March 11, 1988

SUBJECT: ST. LUCIE UNIT 1 - ISSUANCE OF AMENDMENT RE: SPENT FUEL POOL  
EXPANSION (TAC NO. 65589)

SAFETY EVALUATION  
BY THE OFFICE OF NUCLEAR REACTOR REGULATION  
RELATING TO THE RERACKING OF THE SPENT FUEL POOL  
AT THE ST. LUCIE PLANT, UNIT NO. 1  
AS RELATED TO AMENDMENT NO. 91 TO UNIT 1  
FACILITY OPERATING LICENSE NO. DPR-67  
FLORIDA POWER AND LIGHT COMPANY  
DOCKET NO. 50-335

**FIGURE 5.6-1**  
**INITIAL ENRICHMENT VS**  
**BURNUP REQUIREMENTS FOR STORAGE OF**  
**FUEL ASSEMBLIES IN REGION 2**

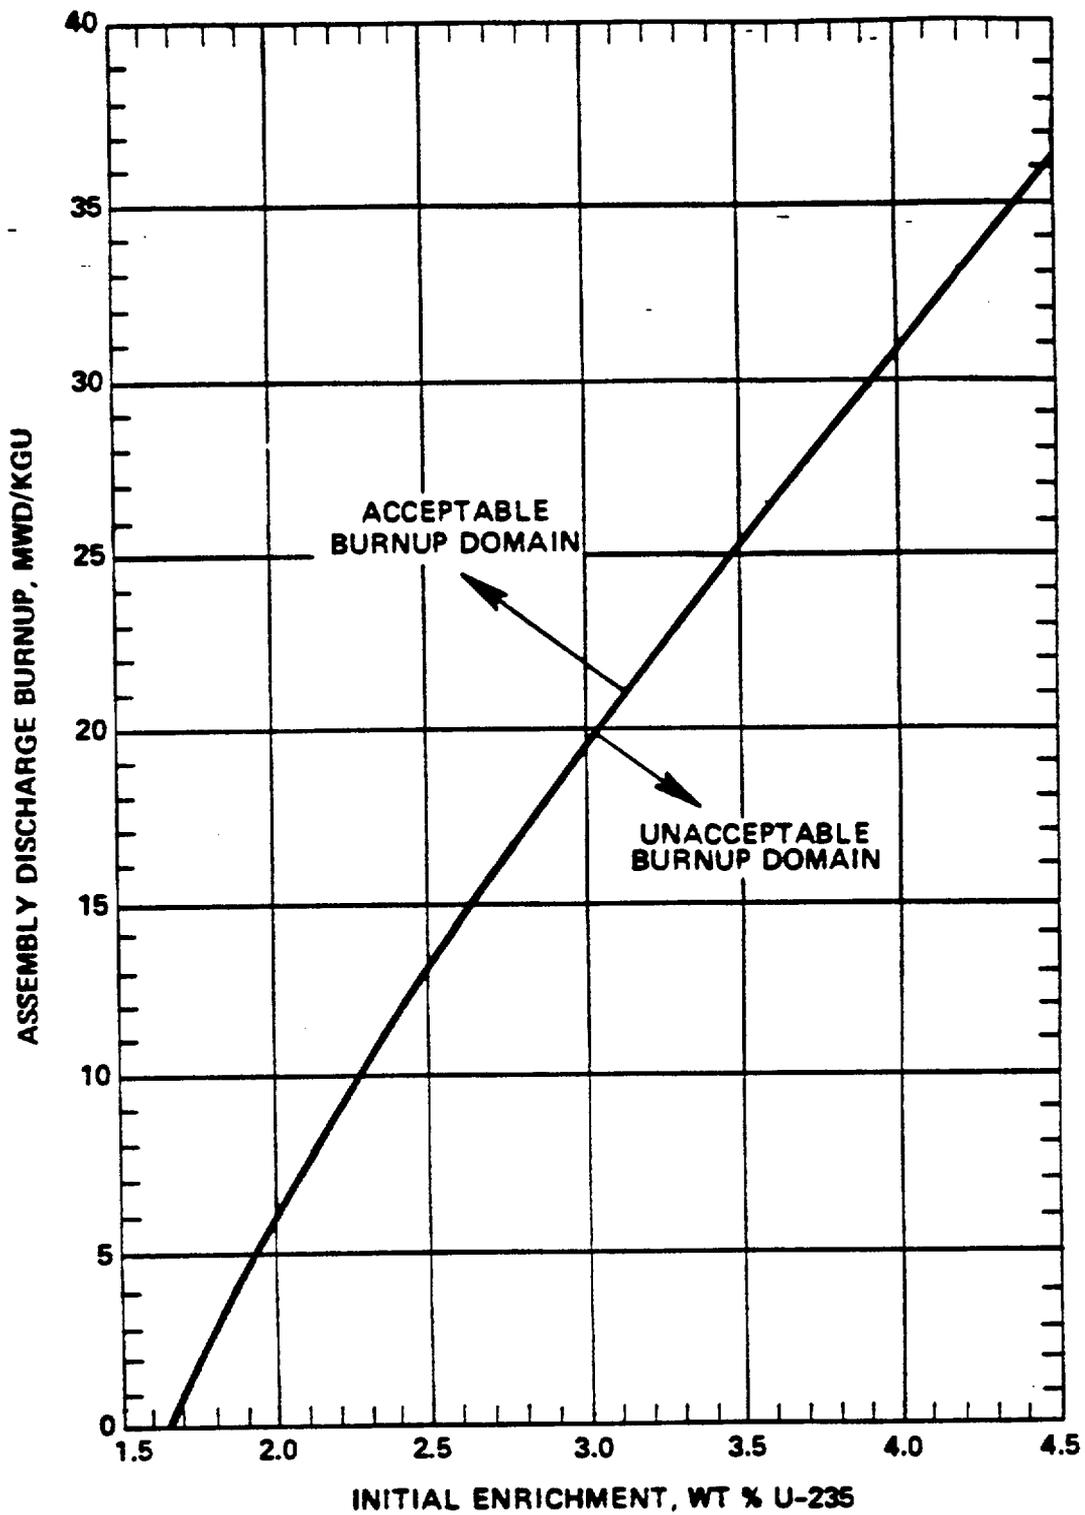
In order to calculate the criterion for acceptable burnup for storage in Region 2, calculations were made for fuel of several different initial enrichments. At each enrichment, a limiting reactivity value, which included an additional factor for uncertainty in the burnup analysis, was established. Burnup values that yielded the limiting reactivity values were then determined for each enrichment from which the acceptable burnup domain for storage in Region 2, as shown in proposed technical specification Figure 5.6-1, was obtained. The staff finds this procedure acceptable.

In the Region 2 analysis, the same uncertainties are considered, except there is no water gap and, hence, no gap thickness uncertainty. In addition, an uncertainty due to the burnup analysis is estimated and treated as an additive term in determining the burnup versus enrichment limiting reactivity values in Figure 5.6-1, rather than being combined statistically with the other uncertainties.

For Region 2, the rack multiplication factor is calculated to be 0.9435 for the most reactive irradiated fuel permitted to be stored in the racks; i.e., fuel with the minimum burnup permitted for each initial enrichment as shown in Figure 5.6-1. The design will accept fuel of 4.5 weight percent U-235 initial enrichment burned to 36.5 MWD/kgU of either the CE or ANF type from Units 1 and 2.

Based on the review described above, the staff finds the criticality aspects of the design of the St. Lucie Unit 1 spent fuel racks to be acceptable. The staff concludes that CE or ANF fuel from Unit 1 or Unit 2 may be safely stored in Region 1 provided that the enrichment does not exceed 4.5 weight percent U-235. Any of these fuel types may also be stored in Region 2 provided they meet the burnup and enrichment limits specified in Figure 5.6-1 of the St. Lucie Unit 1 TS.

FIGURE 1  
SPENT FUEL POOL LAYOUT

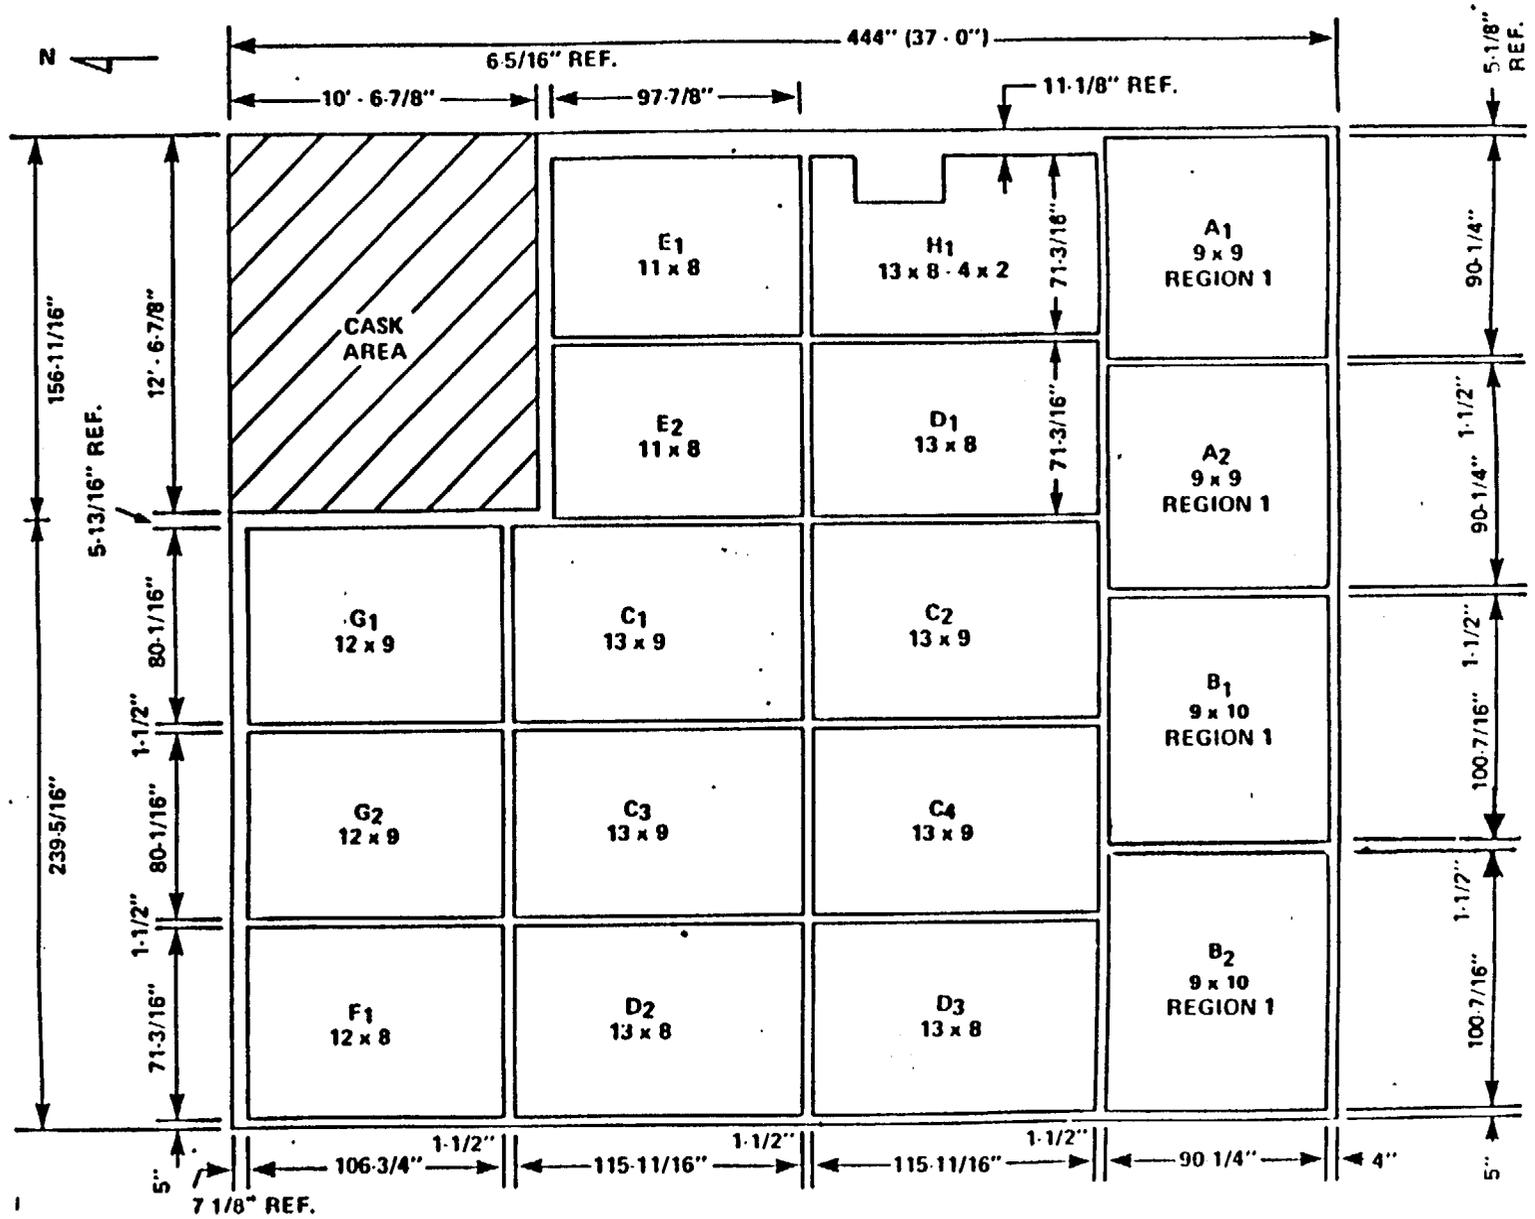
Rack modules B2, G1 and H1 (see Figure 1) were analyzed to show that structural integrity is maintained during a seismic event. The Licensee was asked to provide the basis for selection of these specific racks and gave the following information:

The four racks studied were racks A1, A2, B1 and B2, next to the south pool wall shown in Figure 1. A simplified planar two dimensional model of the row of racks was developed. Each rack was represented by a four degree of freedom model representing horizontal and vertical translations of the rack, planar rotation (rocking) of the rack, and horizontal translation (rattling) of the fuel assemblies. The racks were assumed to be fully loaded with fuel using the nominal fuel weight (1250 lb/assembly) which is half the weight used in the single rack design basis models. Support spring constants, impact spring constants and gaps were consistent with the design basis models. Fuel to cell fluid coupling coefficients were reduced to 50% of the "blunt body" value in an attempt to compensate for the potential overprediction of fluid coupling forces predicted by the design basis models as discussed in Section 4.1.2. Runs were made for both the 0.2 and 0.8 coefficients of friction. The seismic loading of the E-W and vertical SSE were applied simultaneously to the model.

FIGURE 9  
SCHEMATIC MODEL  
OF FUEL RACK

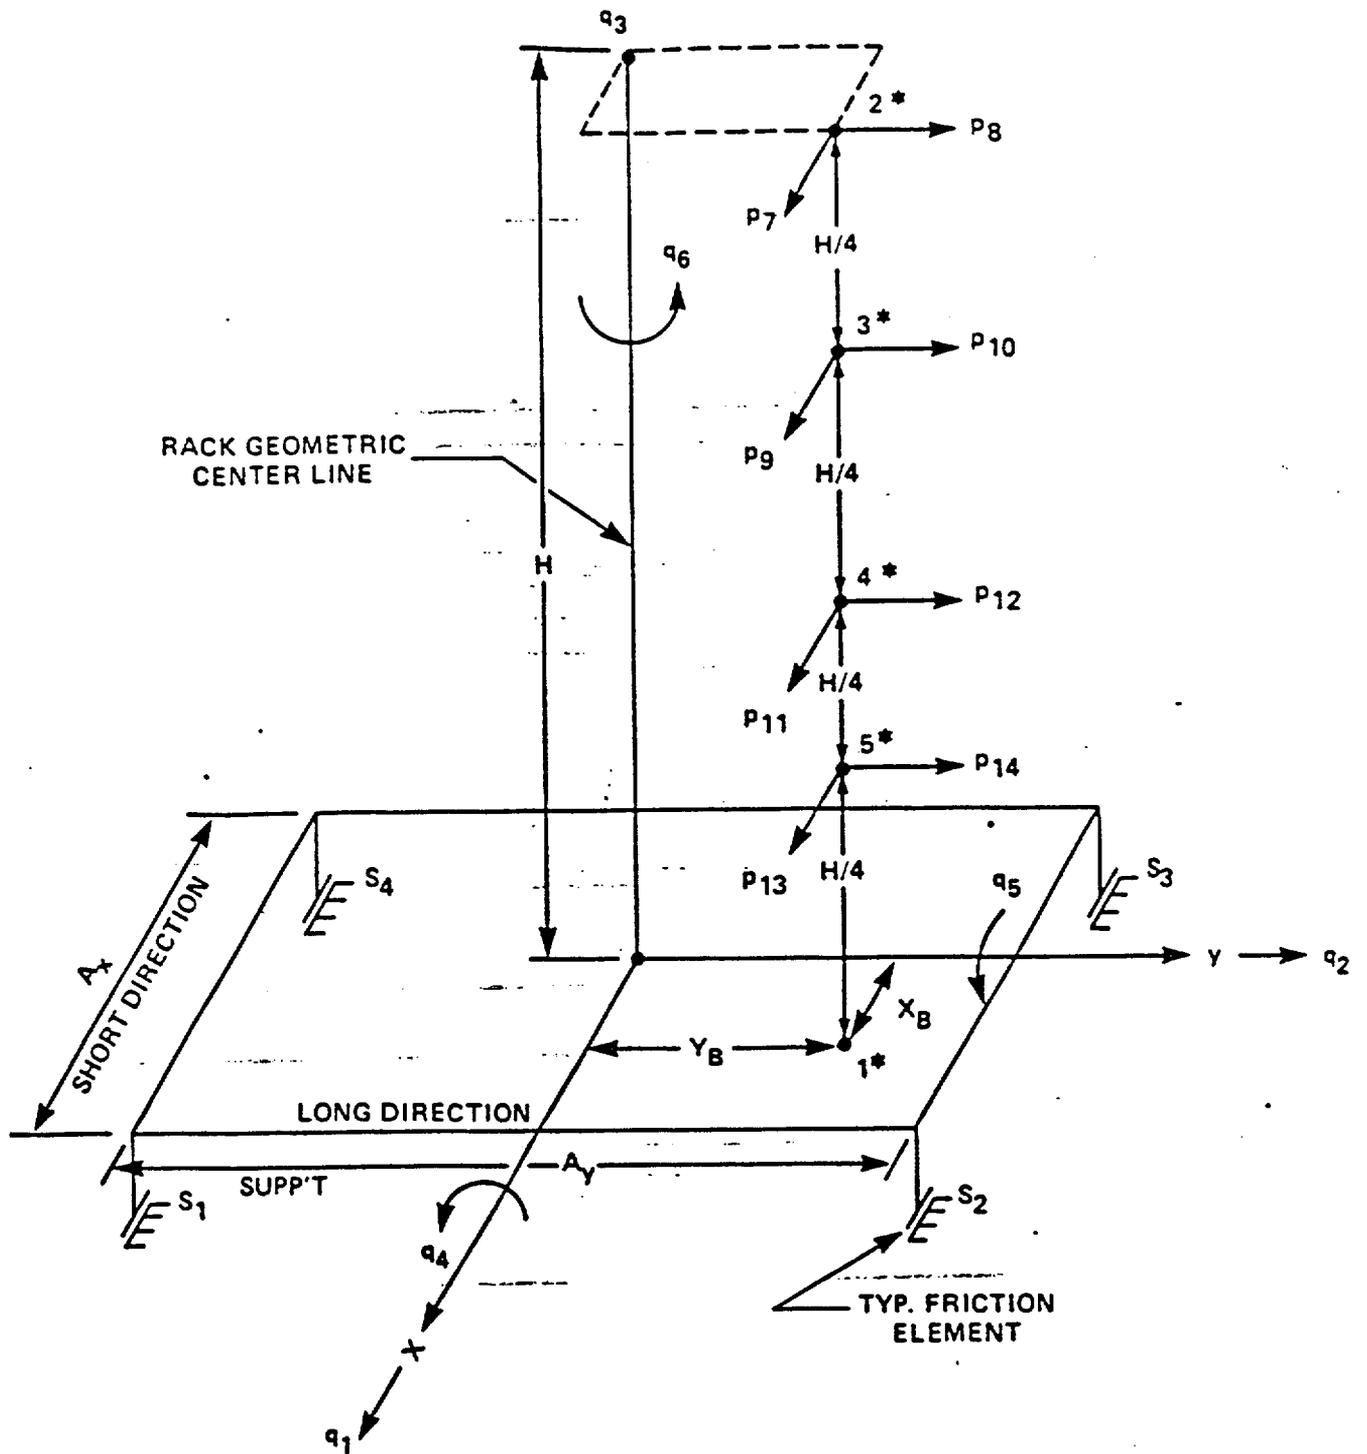
The Licensee's mathematical model of a spent fuel racks module is shown in Figures 9, 10, 11, and 12. The Licensee indicated that the rack structure is very rigid and that its motion can be characterized in terms of six degrees of freedom at the rack base. Figure 9 shows the rack as a rigid stick on a rigid base with three translational ( $q_1, q_2, q_3$ ) and three rotational ( $q_4, q_5, q_6$ ) degrees of freedom. The fuel assemblies are treated as five lumped masses located at different elevations (nodes 1\* to 5\*). All fuel assemblies in a rack module are assumed to vibrate in phase. Each lumped mass is assumed to rattle independently within the rack cell gaps and is represented by two horizontal translational degrees of freedom. Impacts between the rack and fuel assembly lumped masses are accounted for by the use of compression-only gap elements as shown in Figure 11. The support legs are modeled as compression-only springs (S1 to S4 in Figure 9) which consider the local vertical flexibility of the rack-support interface. Friction elements are used at the bottom of the support legs. Figure 10 shows the impact springs acting through gap elements to simulate the interface with adjacent rack modules or pool walls. Five impact springs per side are used at both the girdle bar and baseplate elevations. Figure 12 shows a two dimensional representation of the model with only one "rattling" fuel mass to clarify the overall model concept.

The Licensee was asked to provide justification for treating the fuel assemblies as five independent rattling masses. The Licensee stated that the fuel assemblies have a natural frequency much lower than the rack and submitted additional studies to demonstrate that the effects of coupling the masses are not significant when compared to the overall conservatism of the model. This is discussed in Section 4.2.1. The fuel was modeled as five lumped masses at equally spaced elevations above the baseplate. In reality, fuel-rack impacts would be expected to occur at the nine spacer grid locations and at the upper and lower end fittings. The selection of only five impact locations combined with the assumption that all fuel assemblies move in-phase should result in conservative fuel-to-rack impact loads.

The Licensee was asked to provide justification for the assumption that the motion of the rack can be represented by a rigid six degree of freedom structure. The Licensee indicated that for a typical rack, the lowest natural frequency of the rack gridwork vibrating in water is 32 Hz. For seismic analysis, it is appropriate to consider this as a rigid body whose motion can be described by a six degree of freedom model.
